INTERNATIONAL
URANIUM (USA)
CORPORATION

Responses to NRC Letter Dated August 19, 1997 and December 5, 1997, Regarding NRC
Acceptance Review of the Reclamation Plan for the White Mesa Uranium Mill

Source Material License SUA-1358
Docket No. 40-8681

**Response to Nuclear Regulatory Commission / White Mesa Mill Reclamation Plan
Comments Dated August 19, 1997
Source Material License SUA-1358**

Cell 2 Settlement Monitors

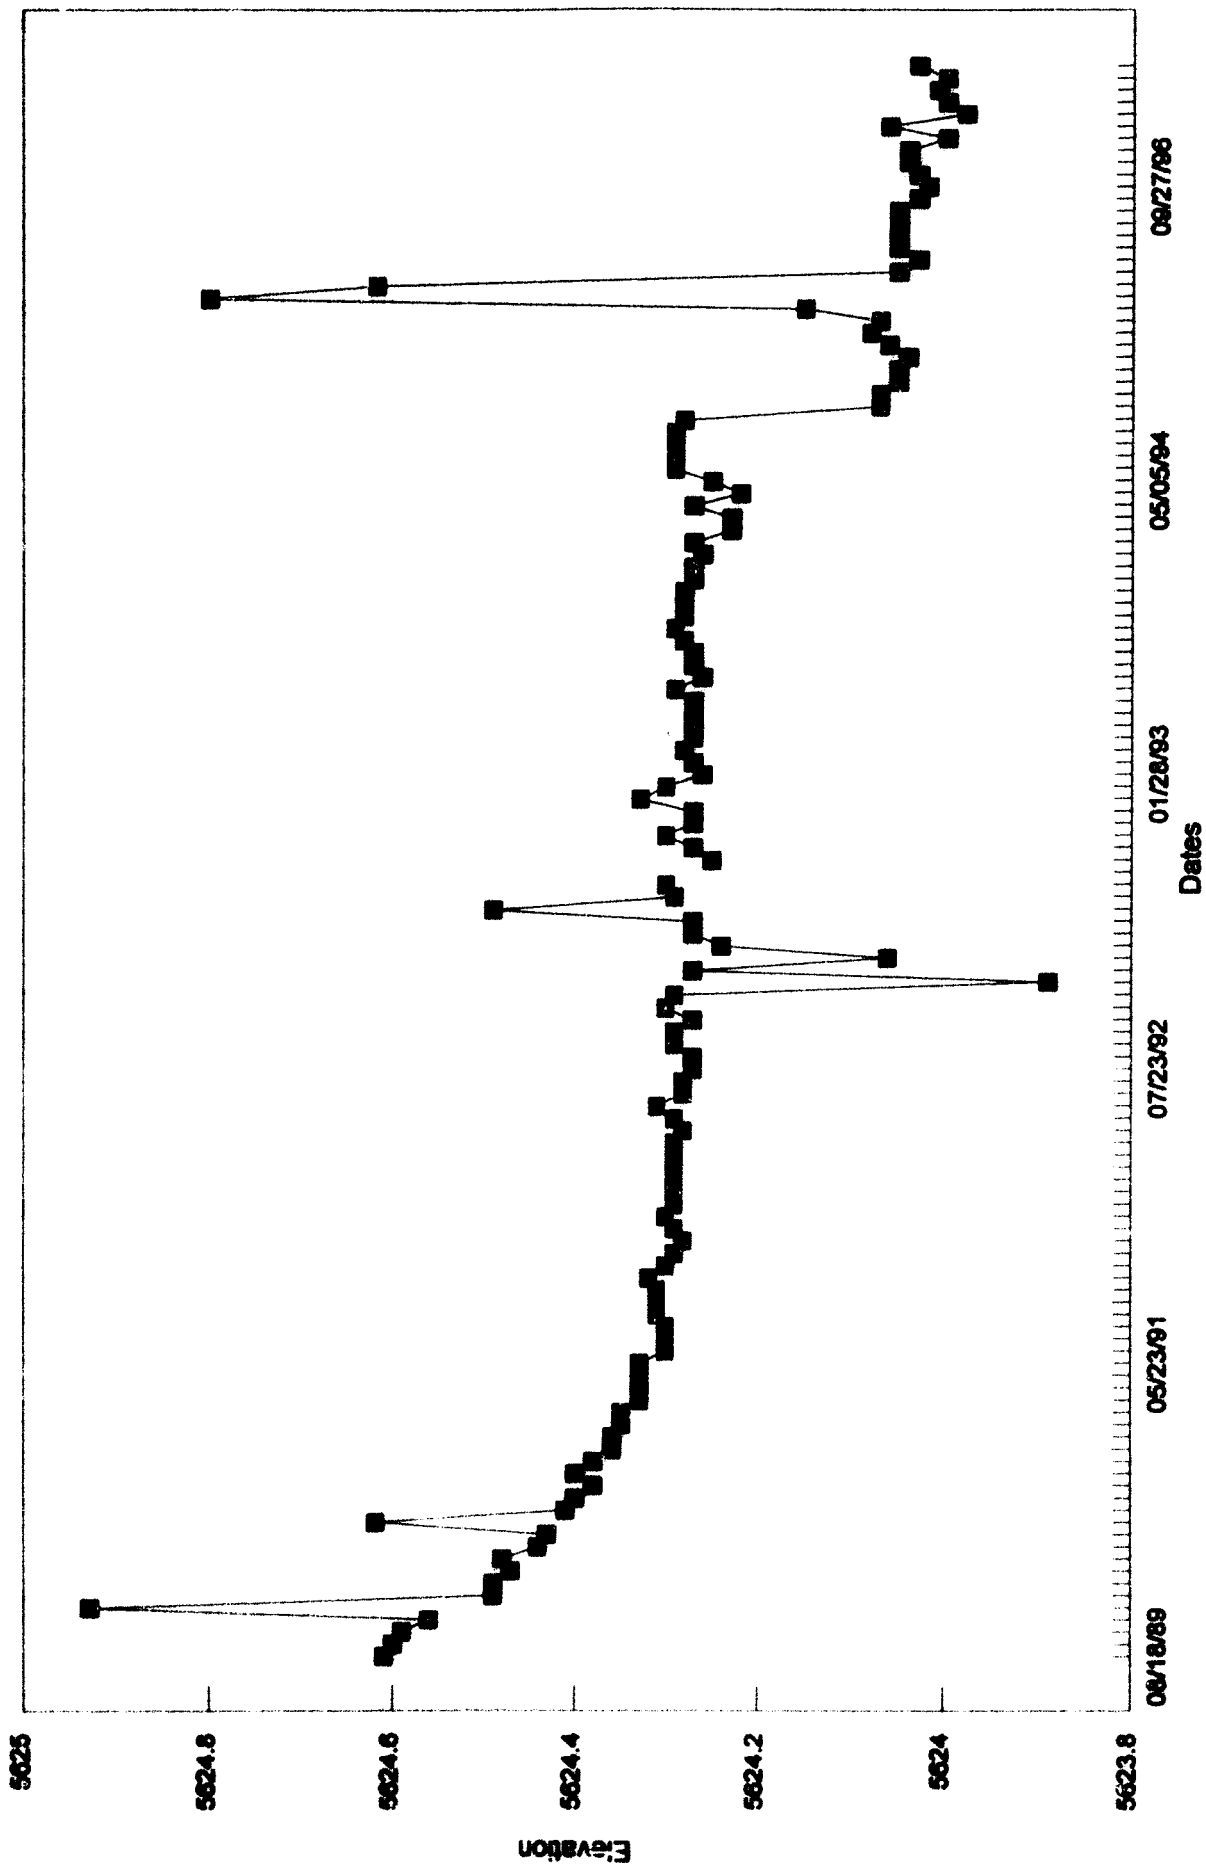
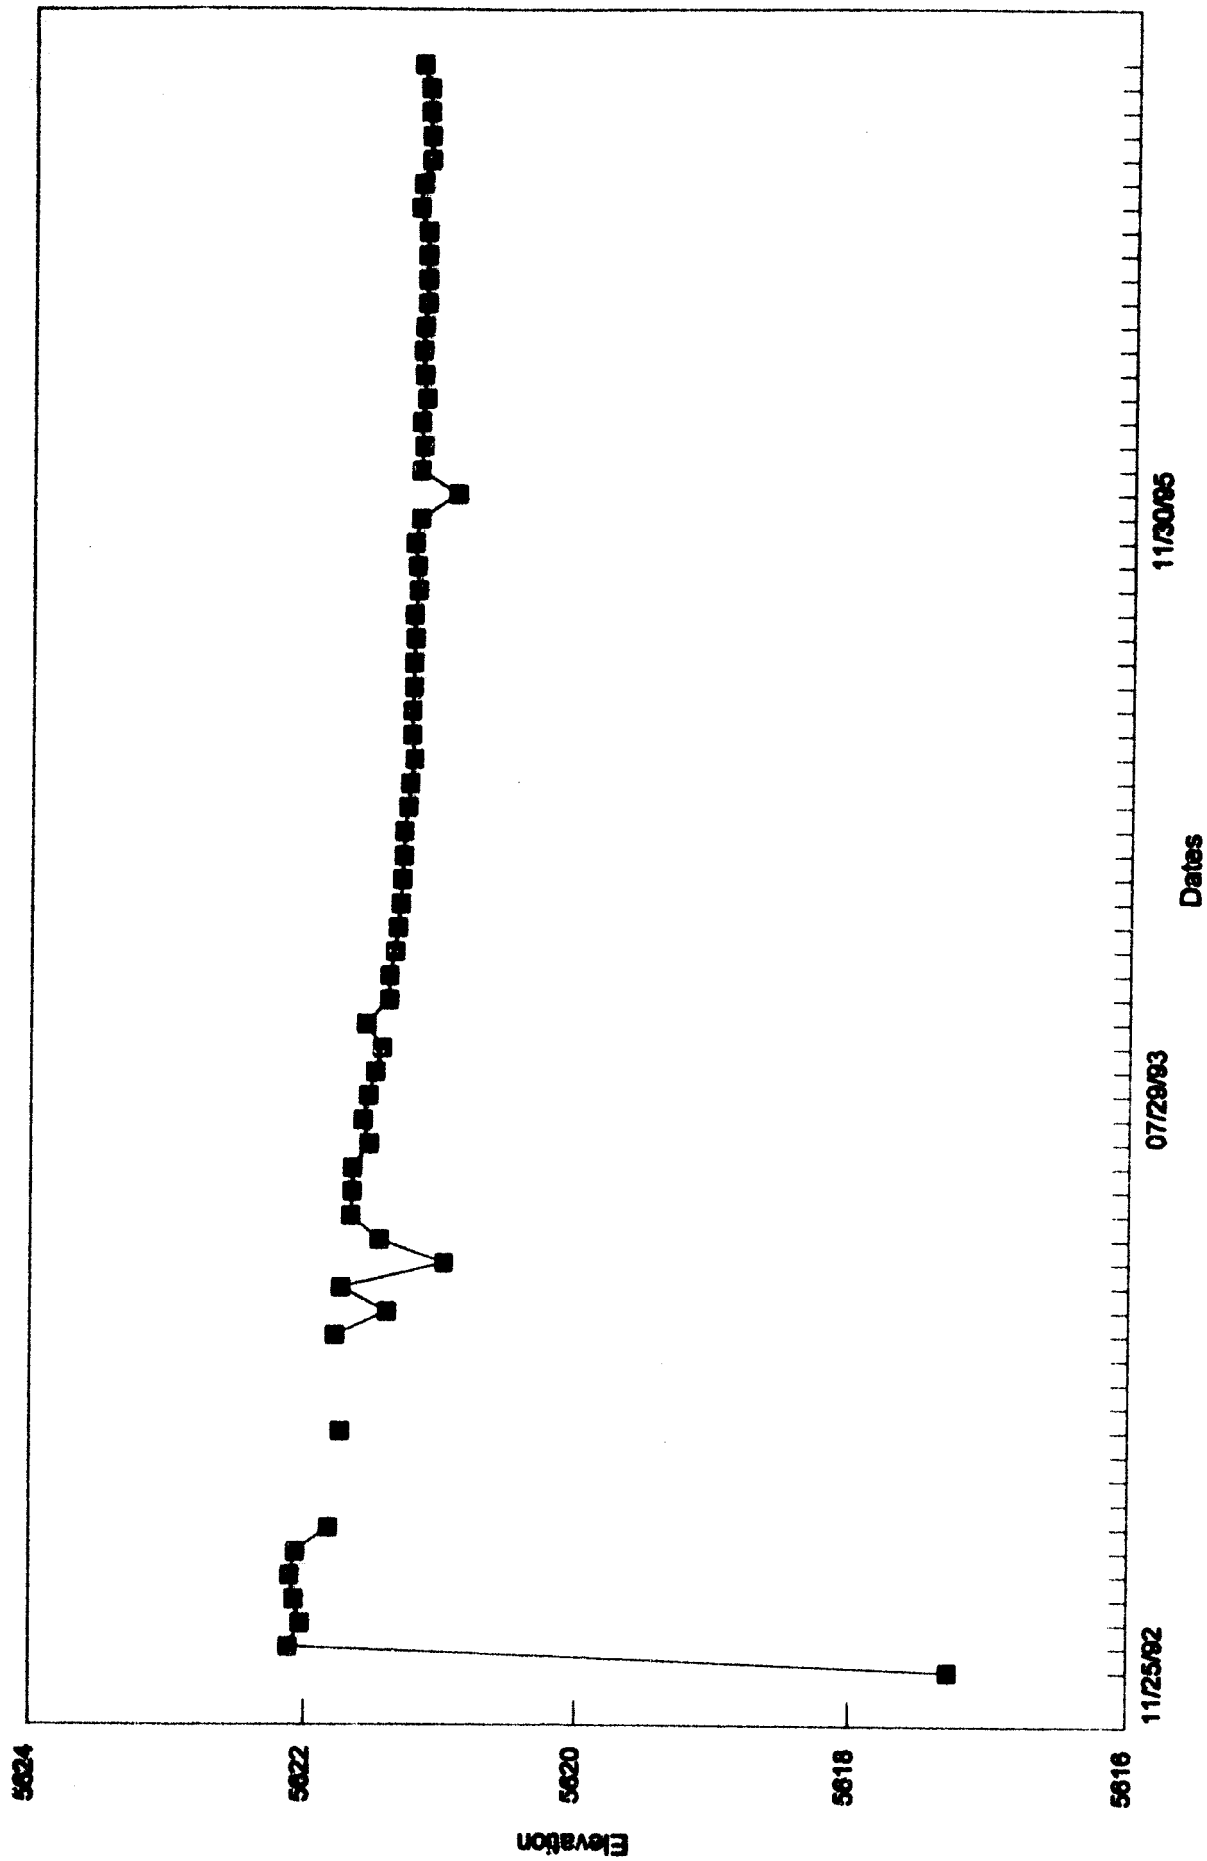
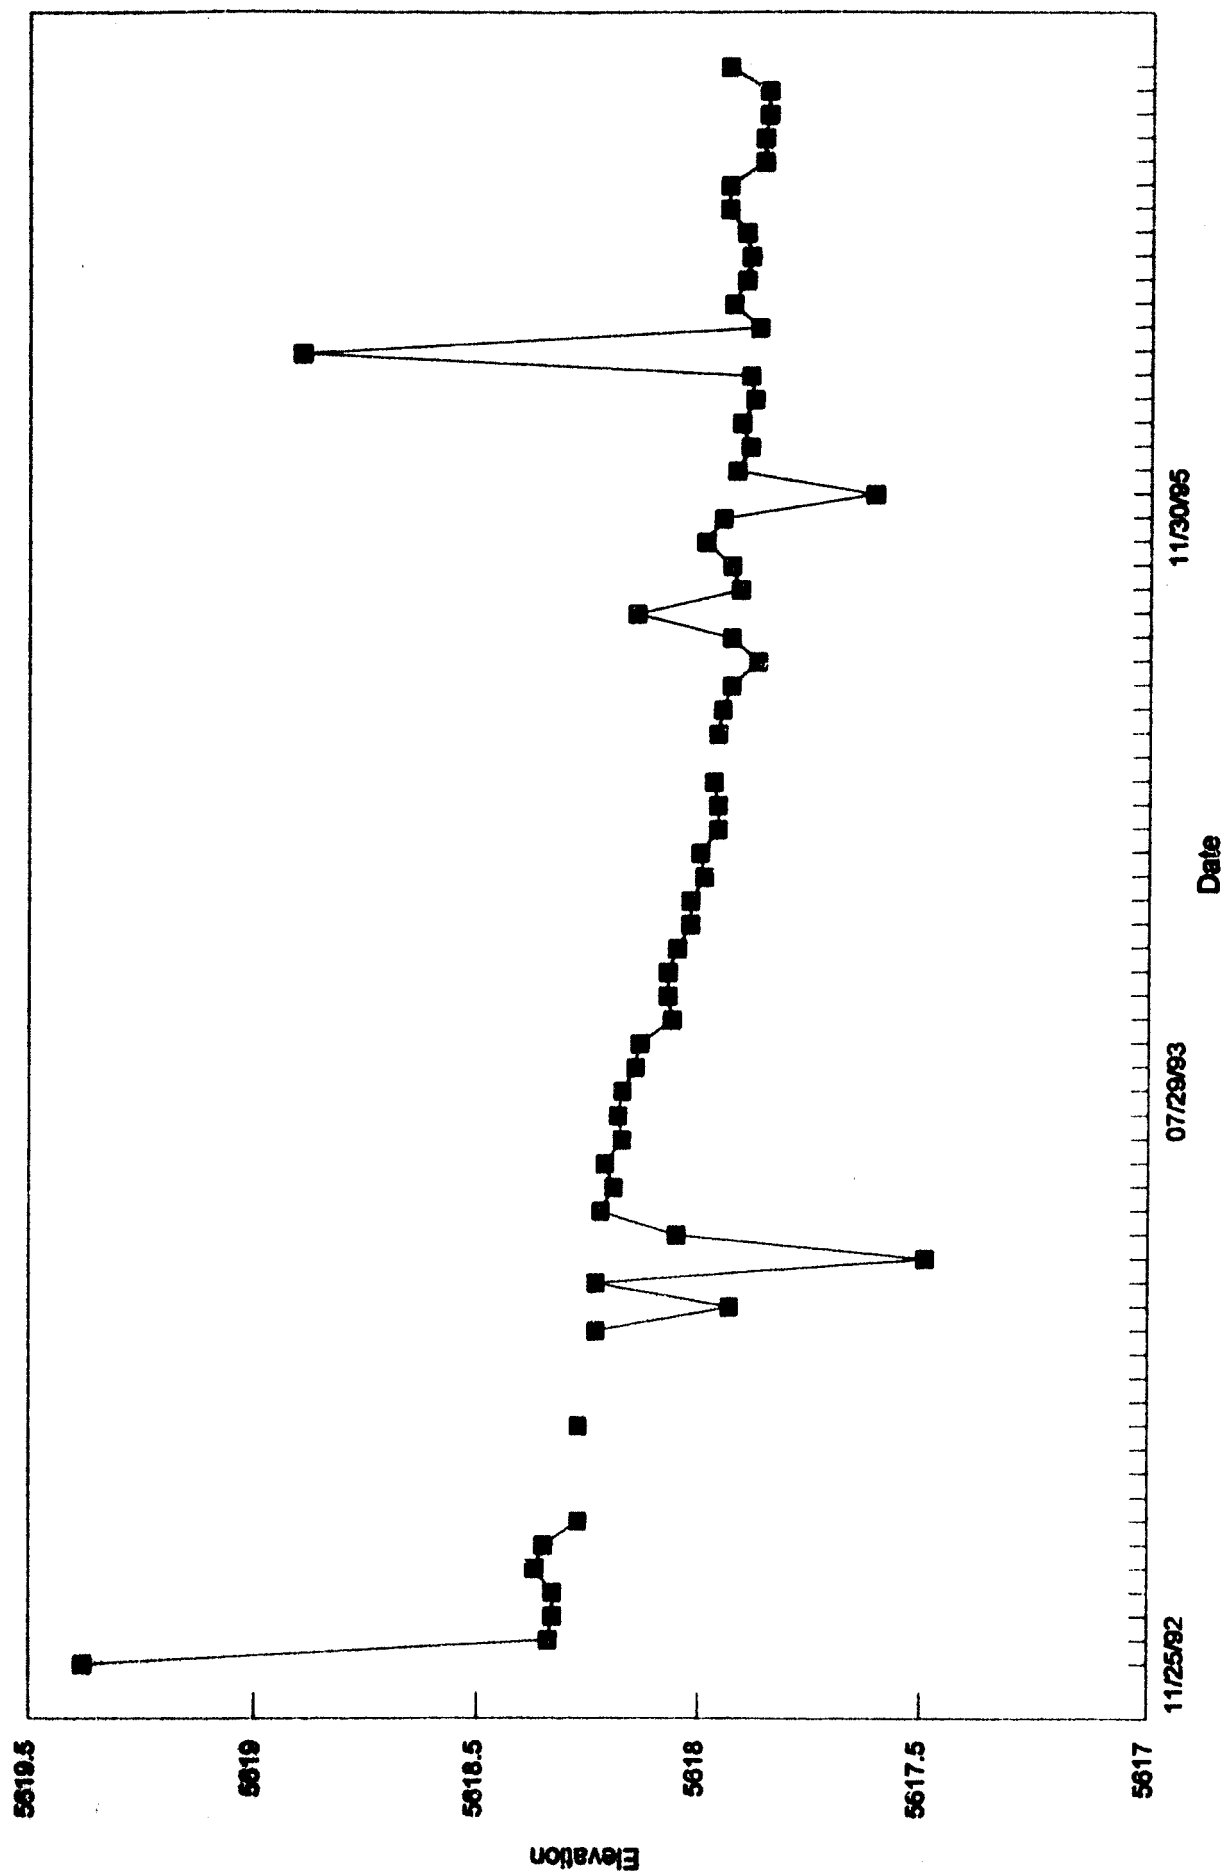
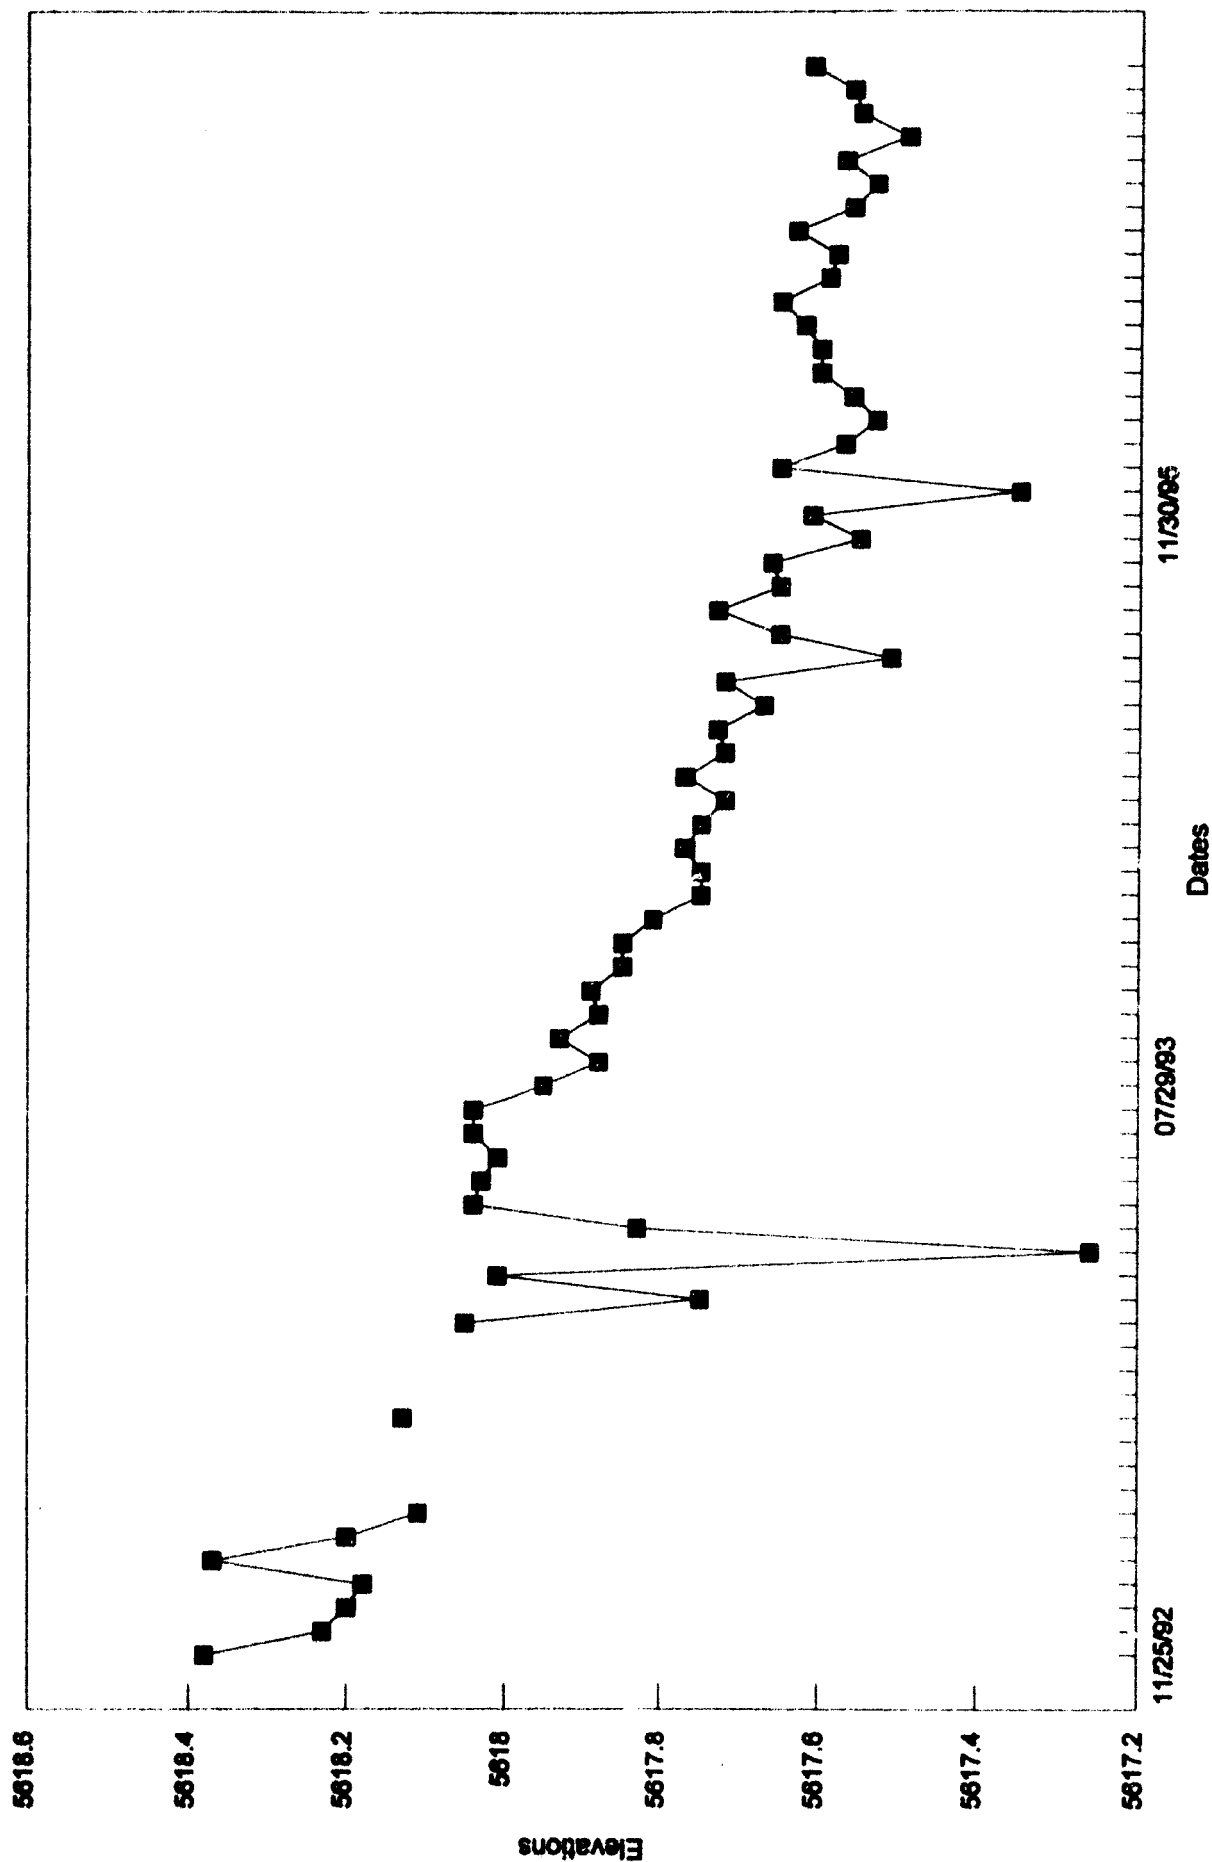
(2) *An analysis of the total and differential settlements of the tailings surface and the effects of such settlements on soil cover integrity.*

Analysis of the total and differential settlement of the tailings surface was performed using the survey data compiled for the five settlement monuments installed within Cell 2. These monuments were installed on the surface of the tailings, between August 1989 and November 1992, prior to the placement of approximately three to four feet of random fill material. Survey results of each monument were plotted as time vs. settlement graphs and are presented in Attachment 2 of this response.

Review of the survey data and graphs shows that primary consolidation of the tailings has occurred, and the settlement rate has been very slow with minor total values. The maximum total settlement recorded is 0.97 feet, and the differential settlement is on the order of 0.50 feet. Approximately 81 percent of the total measured settlement occurred within the initial three years. Additionally, recent survey data indicates that the settlement has virtually stopped. From September 1995 to September 1997 the settlement averaged less than 0.03 feet per year, which is within the expectable survey error of 0.05 feet. This indicates that the settlement since 1995 is negligible.

Placement of the final reclamation cover will induce additional settlement. However, since primary consolidation of the tailings has occurred, under current loading conditions, additional settlement is expected to be less than the total settlement values to date. This minor amount of additional settlement, due to the added surcharge of the cap, will not effect the integrity of the six foot thick final reclamation cover.
